Technical change to module RS DIN C 64S LP2N

PCN-number: 20231221
This document has indefinite validity from today

RS Interface product (w/ LP2N
and flat connector)

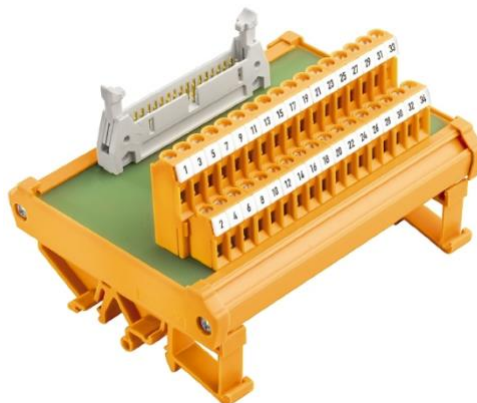
Article on Section 5 was delivered in the past with LP2N connectors. In addition, it was delivered with Dekafix*

Based on continuous improvement, the LP2N connector will be respectively replaced by LL2N connectors.
Furthermore, all the connectors will be marked with KSW strip markers.

Obsolescence of LP2N connector range.
